## TECHNICAL MEMORANDUM

**SUBJECT:** 190th Street Warehouse Project Noise Impact Analysis Addendum (GGI Project No. 19260)

**APPENDIX A**  
**UPDATED PROJECT SITE PLAN**

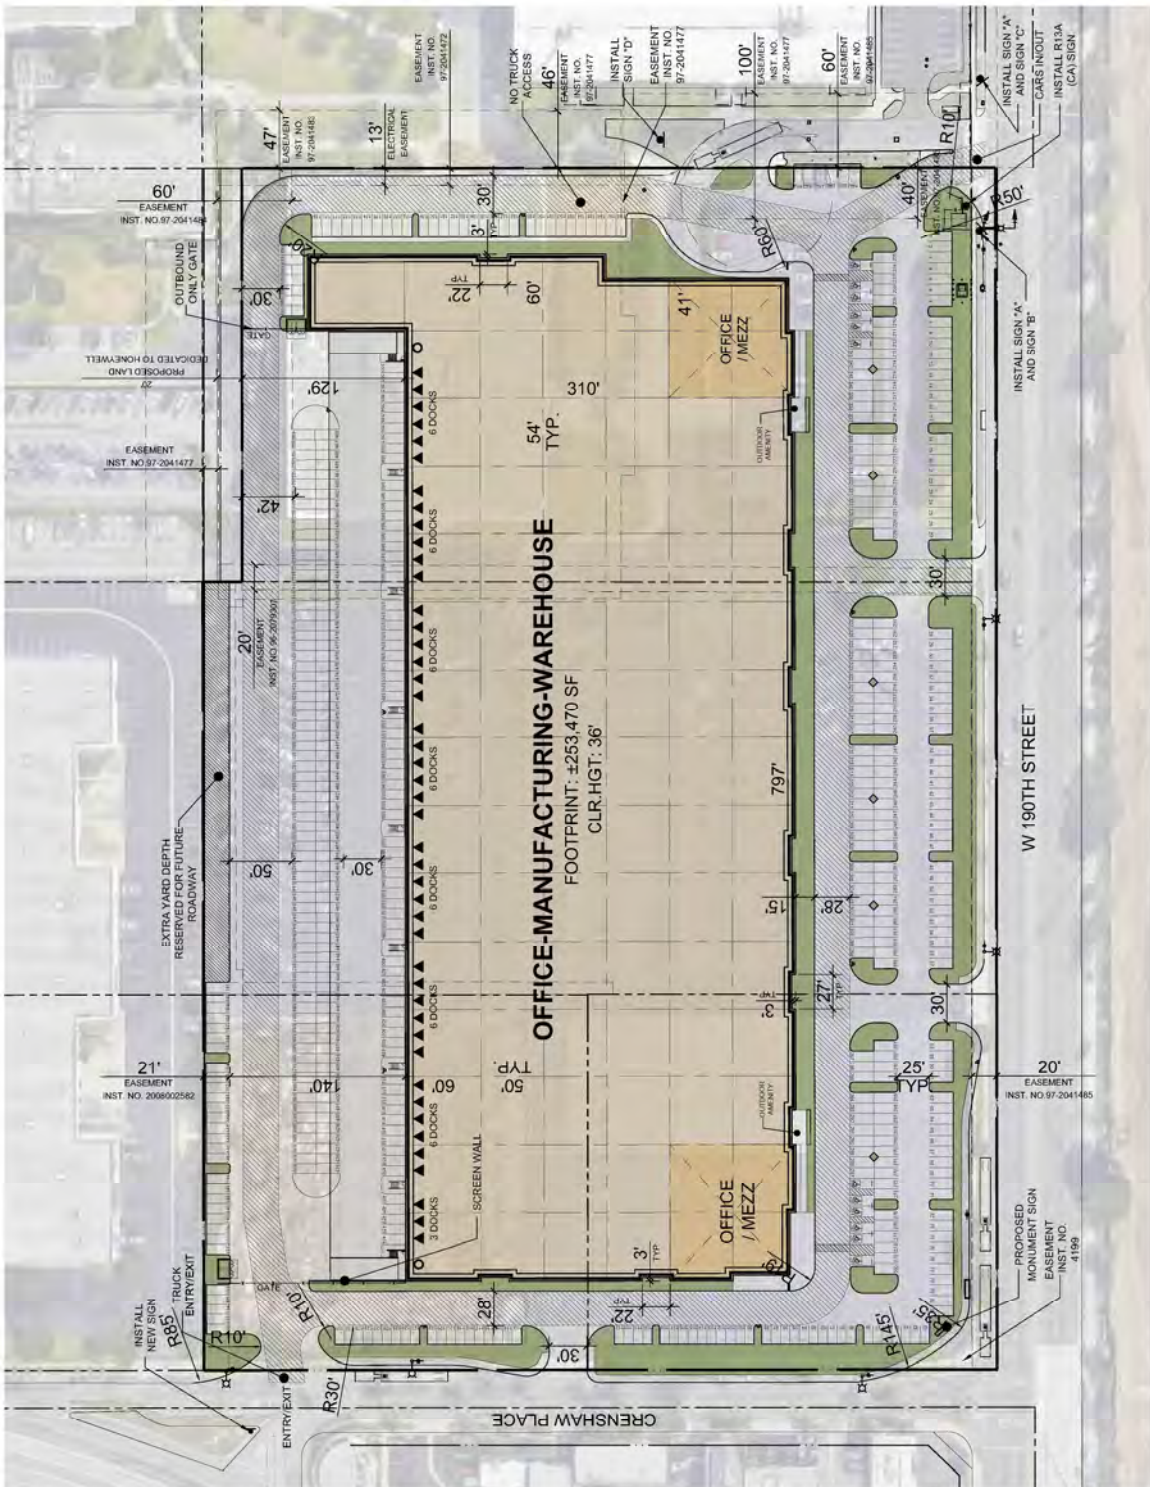
The new site plan does not significantly change the distance between the proposed building and acoustically significant roadways. This impact would remain the same.

The latest (smaller) version of the proposed building will not bring on-site noise sources closer to existing sensitive receptors. This impact would remain the same.
